Final Environmental Impact Statement/Response to Submissions
on the Environmental Review and Management Programme for
the Proposed Wheatstone Project

February 2011

Wheatstone Project

Figure 2.5: Alternative MOF Layout

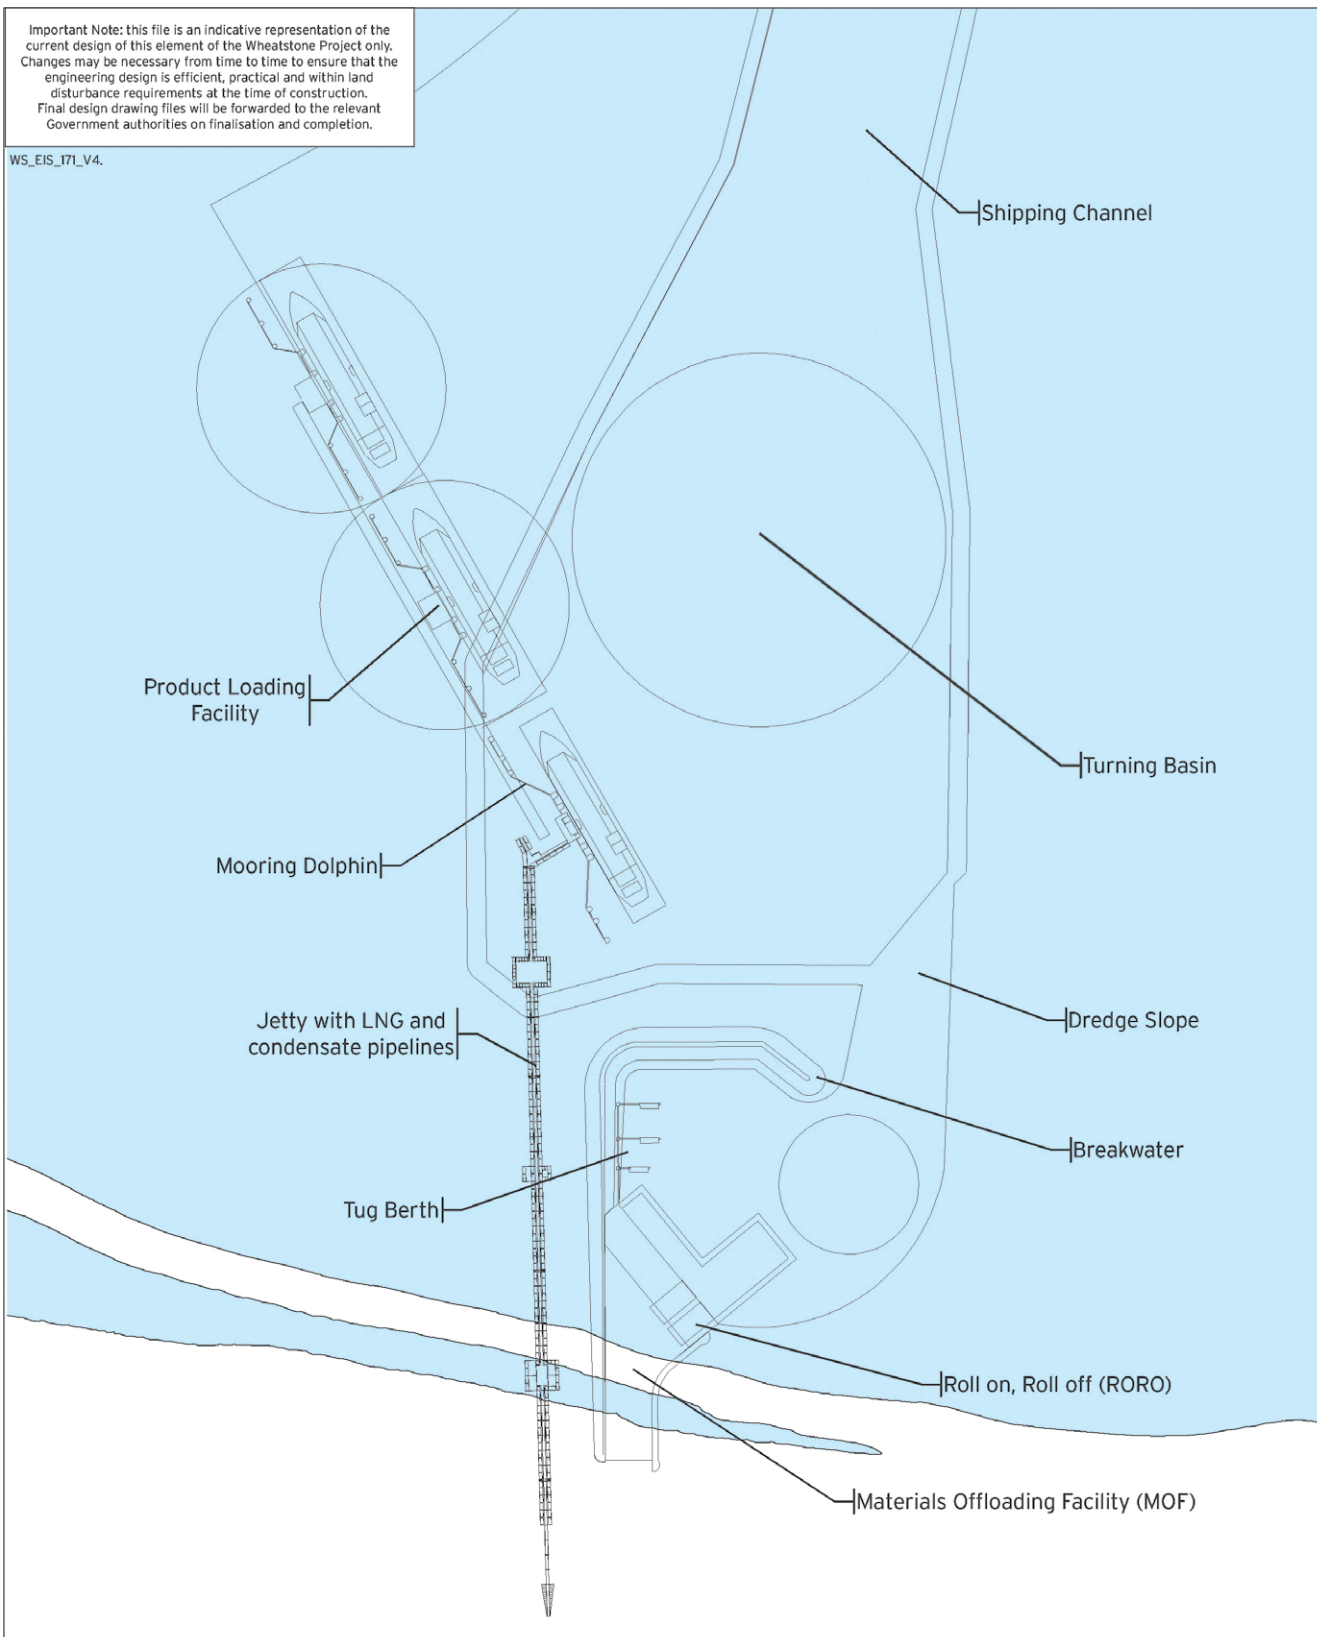
The Draft EIS/ERMP assessed a MOF comprising two combined breakwater and sediment infill protection walls which enclose a small boat harbour and cyclone shelter on the western side, plus three large-vessel berths that can all be operated concurrently (see Figure 2.17 of the Draft EIS/ERMP). As part of the continued development of the Project design, an alternative MOF layout to the base case assessed in the Draft ERMP/EIS has been proposed.

Remodelling of the three key areas with the alternative MOF layout has been carried out and compared to the findings for the base case layout for all three components. The results are summarised in the following sections. The alternative layout is presented in Figure 2.5, and a more detailed assessment is found in Appendix FJ of this document.

Figure 2.6: Nearshore Trunkline Route Alternatives Currently under Investigation by Chevron

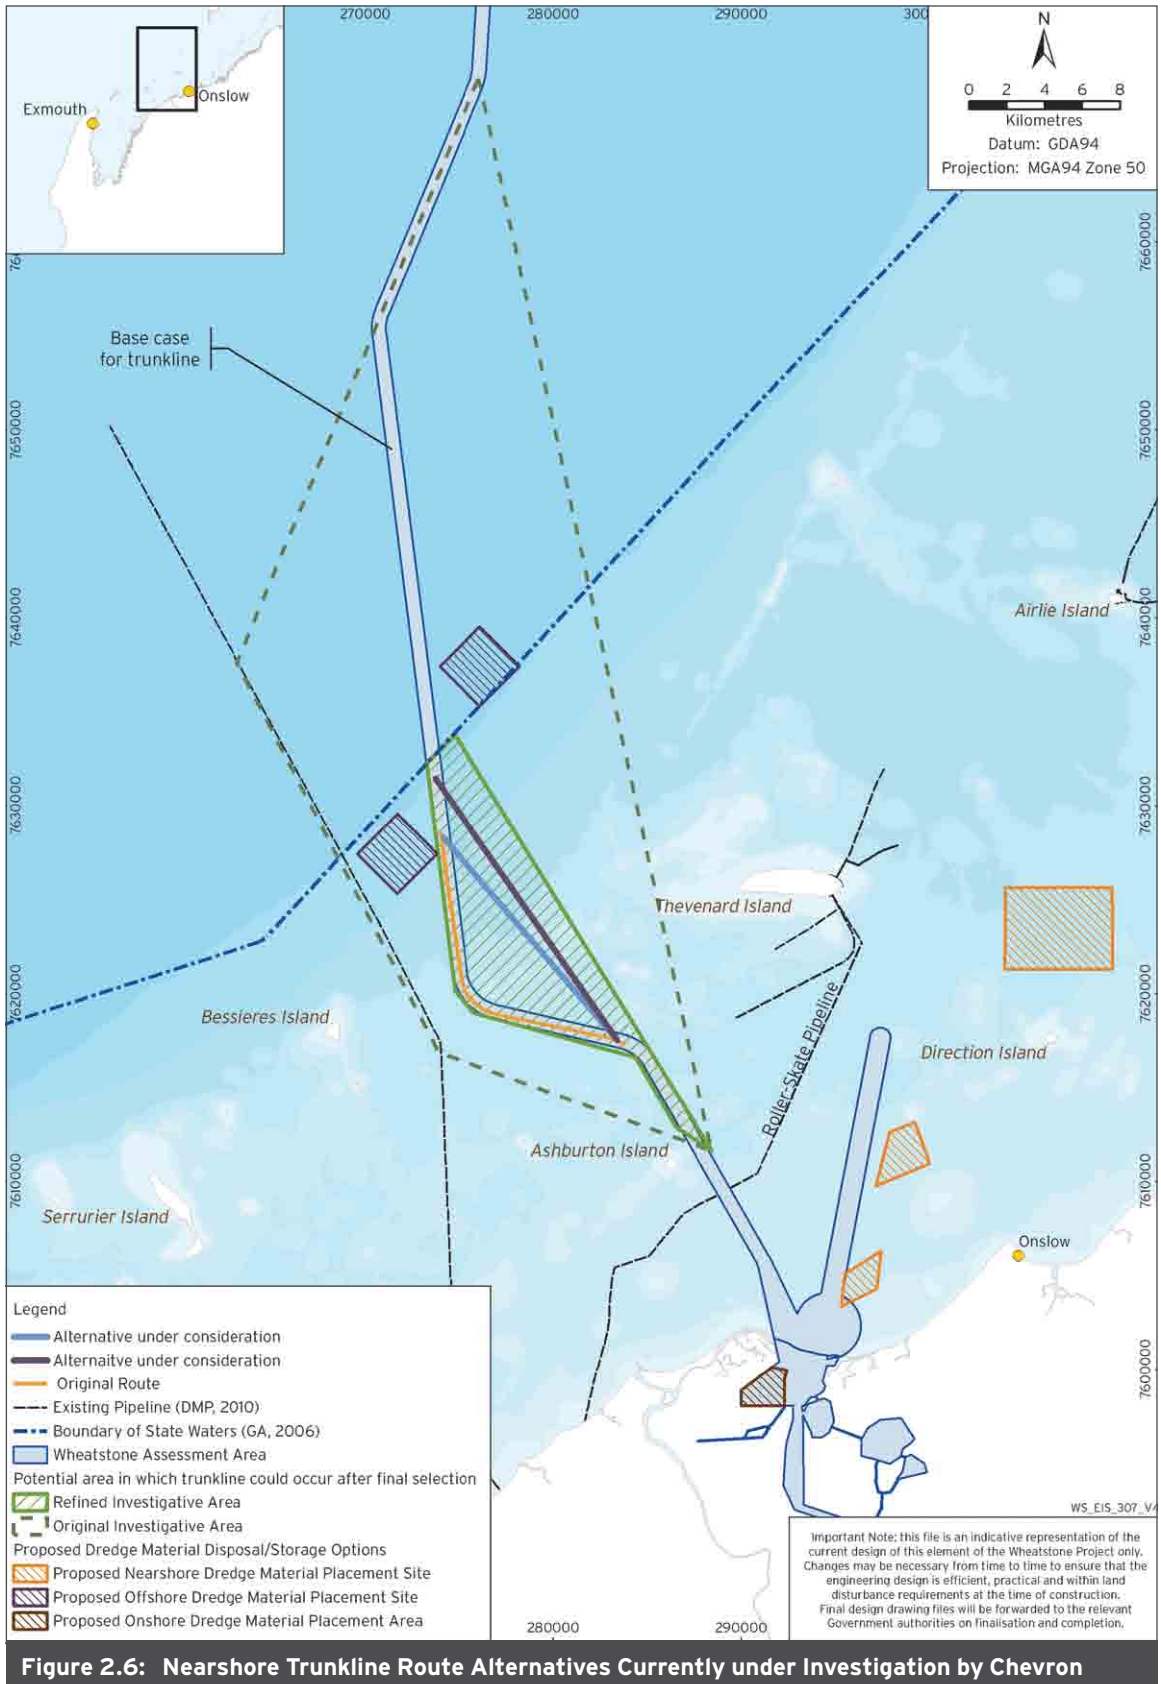
16.	Revision	Trunkline trenching and stabilisation	Trunkline route as shown in Figure 8.13 in Section 8.2.5.4 of the Draft EIS/ERMP.	Potential alternative trunkline routes are shown in Figure 2.6 of this document.	<p>Yes - The alternative route will also result in potential impacts to BPPH. However, the level of BPPH loss will be less than originally predicted in the Draft EIS/ERMP because the alternative trunkline route will be shorter than the original proposed trunkline.</p> <p>Refer to Section 2.2.2 of this document.</p>

Updates to the Project conducted since the publication of the Draft EIS/ERMP have led to the consideration of a potential change in route for the trunkline where it passes to the west of Thevenard Island. Alternative routes currently under investigation are shown on Figure 2.6. Confirmation of the proposed trunkline alignment in this area is ongoing. Consequently, approval is now sought for installation of the trunkline along an alignment to be confirmed within the green hatched area shown on Figure 2.6, labelled as “Refined Investigative Area”.

The Proponent now seeks approval to potentially adopt a shorter trunkline alignment to the west of Thevenard island within the area indicated on Figure 2.6, and commits to protecting the coral reefs around Ashburton and Thevenard islands and Brewis Reef from damage as a result of pipeline installation works, by adopting whichever mitigation action is considered to be most appropriate under the climatic conditions prevailing at the time of construction.

Figure 3.5: Movement of Tagged Whale Sharks

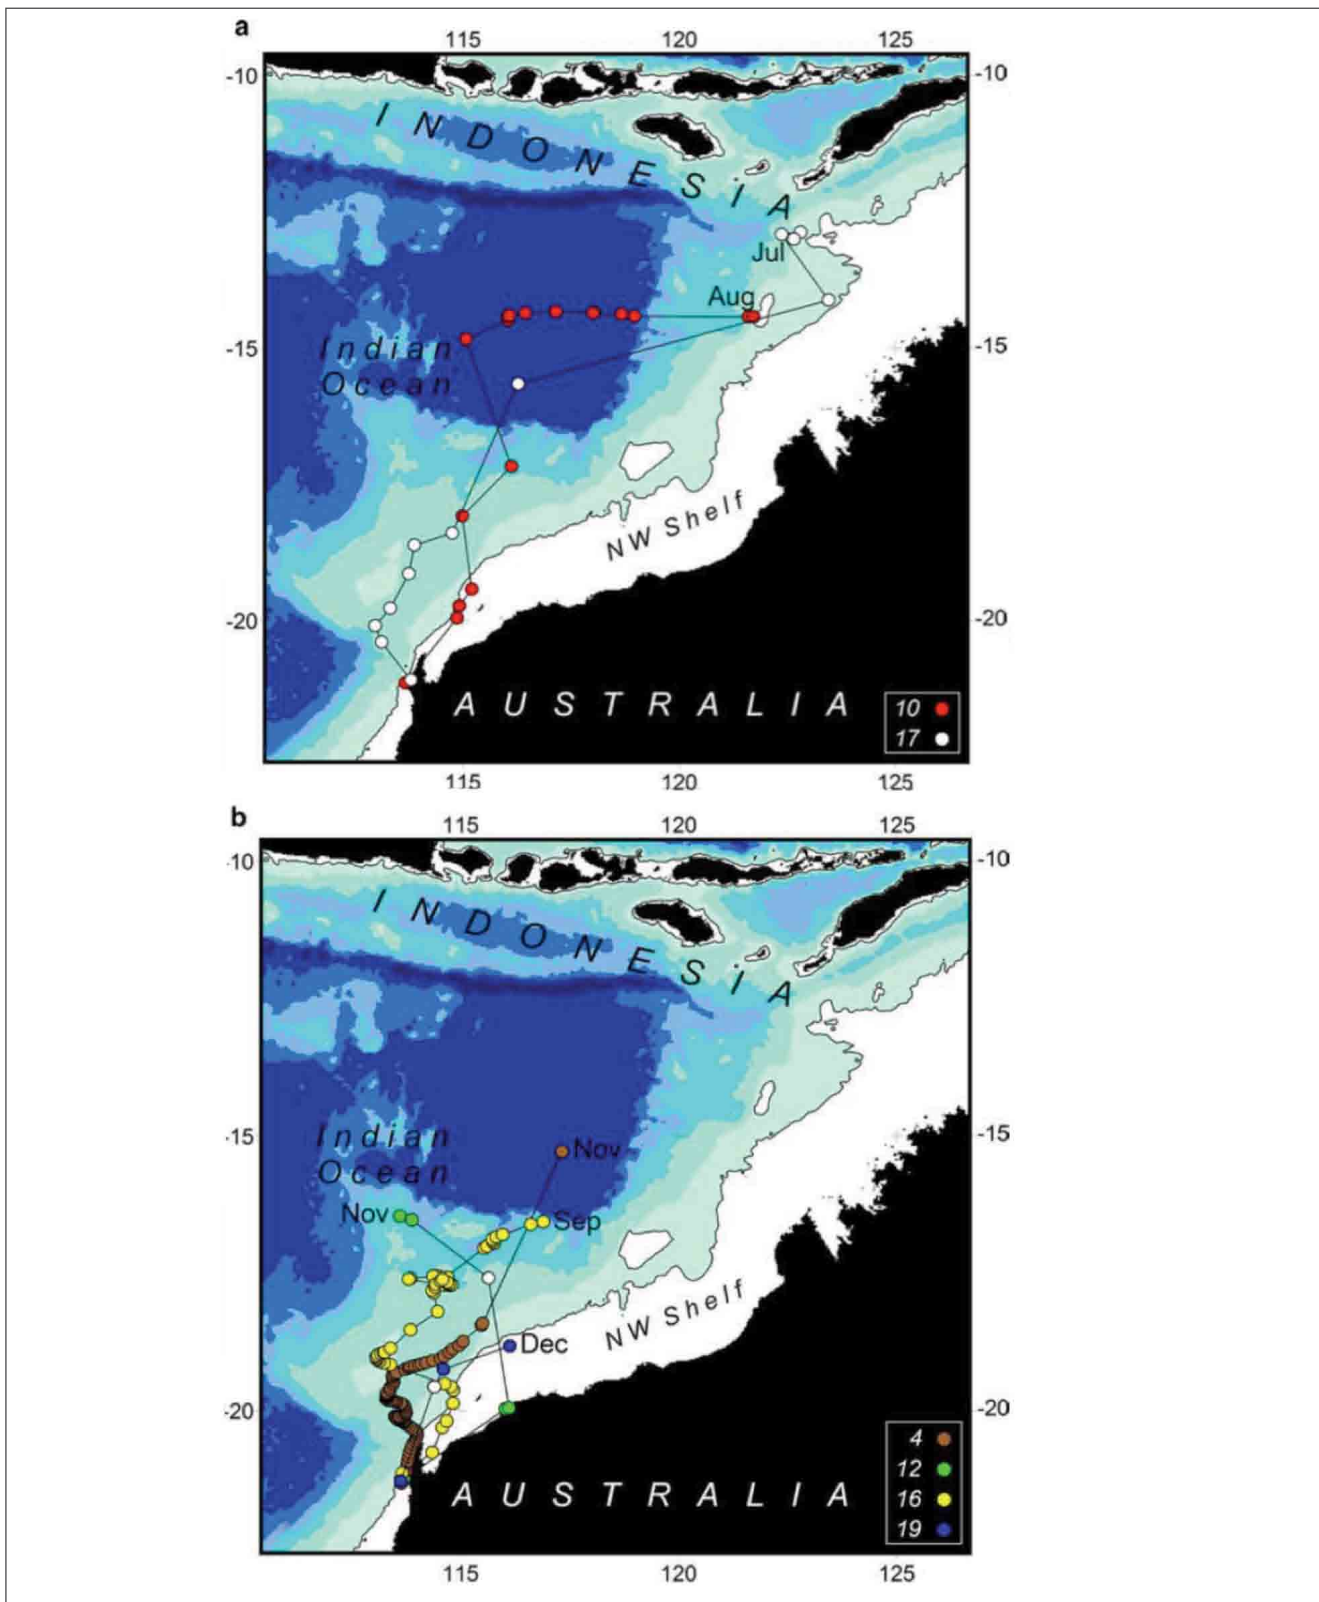
20.26	<p>Assumed use of the Project footprint by the Whale Shark appears to be based on incidental sightings within the cetacean-focused aerial surveys. While little is known about the habits and habitats of the whale shark they are not mammals and do not necessarily spend time at the surface - making aerial surveys of limited value. Being filter feeders whale sharks could be particularly susceptible to contamination or sediment in the water column. It would reasonable to request that the presence and effect on whale sharks is more fully researched in the literature and through liaison with Whale shark experts such as Brad Norman (Ecocean) and/or Mark Meekan (AIMS).</p>
<p>Sufficient pre-existing knowledge of whale shark movement in the Project area is available to support the risk assessment for this species, classified as being 'Low'. Aerial surveys, completed over 12 months from May 2009 to April 2010, recorded only four whale shark observations, within and adjacent to the Project area (Appendix FD of the document). A majority of survey time was spent surveying transects over shallow (>15 m), clear water, thus improving the opportunity to spot whale sharks just below the surface.</p> <p>The data obtained from the aerial surveys is supported by previous whale shark satellite tracking studies by Wilson <i>et al.</i> (2006). This tagging survey indicated that, of those individuals tagged, most whale sharks travelled north-east along the Continental Shelf before moving into the deeper waters of the north-eastern Indian Ocean, and away from mainland coast of Australia.</p> <p>As the risk assessment process determined the risk to whale sharks to be 'Low', no further research will be completed.</p> <p>Refer to Figure 3.5.</p>

The data obtained from the aerial surveys is supported by previous whale shark satellite tracking studies by Wilson *et al.* (2006). This tagging survey indicated that, of those individuals tagged, most whale sharks travelled north-east along the Continental Shelf before moving into the deeper waters of the north-eastern Indian Ocean, and away from mainland coast of Australia. (See Figure 3.5).

Figure 3.7: Coastal Erosion affecting Tidal Entrances

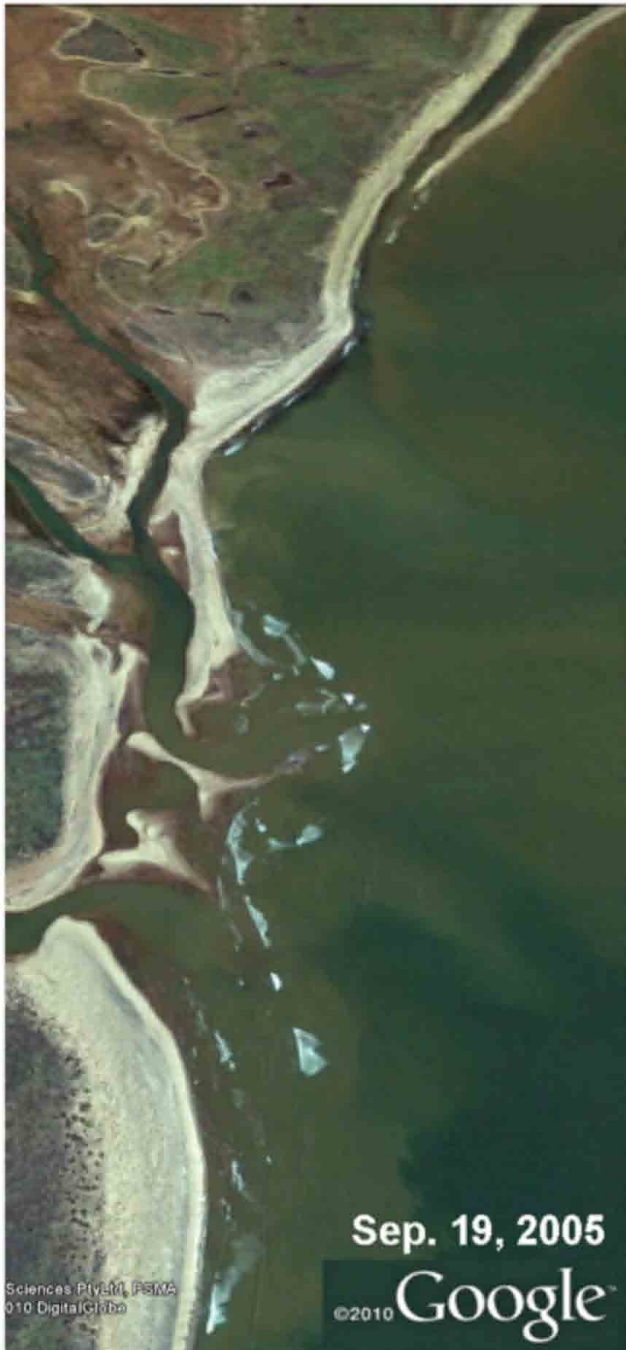
Refer to Figure 3.7.

- The average relative depth alteration at the placement ground is very limited.
- The waves are limited in height and mainly short period, which limits their penetration to and impact by the seafloor in the water depths at the placement ground.

The placement ground is far from shore, and the limited impacts are not felt that far away from the coastline.

Figure 3.8: Strong Winds Recorded at Onslow and Barrow Island

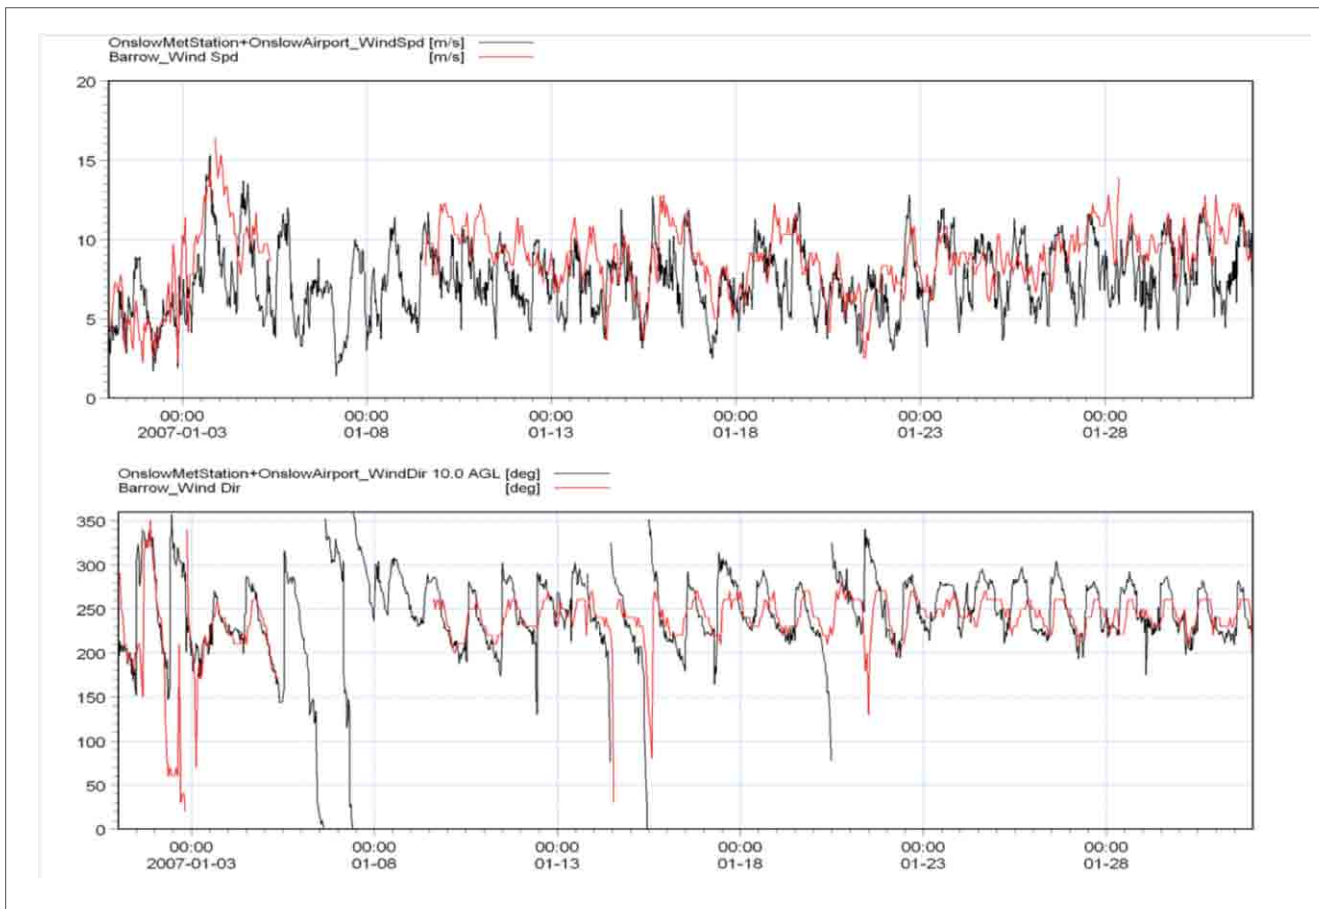
29.10	<p>In Section 3.2.5, there is the introduction of a “rough” wave conditions scenario, but it is uncertain where this has been defined.</p>
	<p>The definition of the rough wave condition was omitted from the Draft EIS/ERMP (Appendix P2) due to oversight. The rough wave condition was introduced by choosing a period which included strong winds in the first week of January, 2007. Figure 3.8 illustrates the stronger winds as recorded at Onslow and Barrow Island during January 2007.</p>
